TechNotes

#535

05/14/2024

Best of April 2024

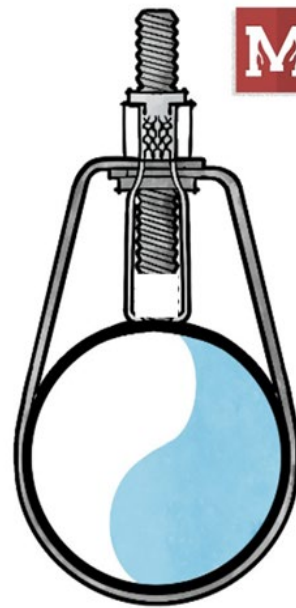
Question #6 - Rod Run Down to Pipe

A system has pressures that exceed 100 psi. Section 9.2.3.4.4 in the 2013 edition of NFPA 13 requires that for unsupported lengths, the end sprinkler has a hanger that prevents upward movement.

Is running an all-threaded rod all the way down to the pipe an acceptable method to prevent upward movement of the pipe?

Yes, as detailed in Annex figure A.9.2.3.4.4(b), running the hanger rod tight to the piping is one method to avoid upward movement for the end-of-line pendent sprinkler. Hanger manufacturers also make available restraining or surge clips that can fill the void and restrain the pipe from moving upward.

This annex figure shows examples of acceptable hangers for preventing upward movement.

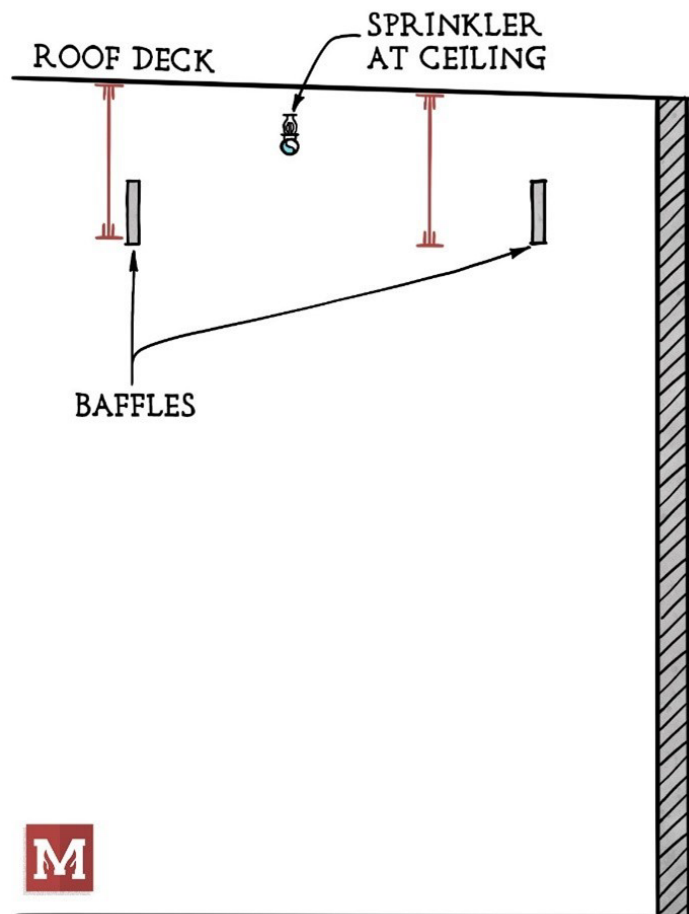
Question #12 – Baffle Obstruction

In an ordinary hazard occupancy, suspended ceiling baffles are present as shown in the figure below standard spray upright sprinklers. As the baffles are not structural and are located below the upright sprinklers, can the three times rule be ignored as noted in Section 8.6.5.2.1.4 of the 2016 edition of NFPA 13?

Yes, since the baffles are completely below the sprinklers, water from the sprinklers will get to two sides of the baffle. Therefore, the baffles can ignore the “three-times” rule per Section 8.6.5.2.1.4 since baffles are not structural members. The answer would have been different if the baffle was tight to the ceiling or if the top of the fixture was above the plane of the deflector. The installation as shown appears to be compliant.
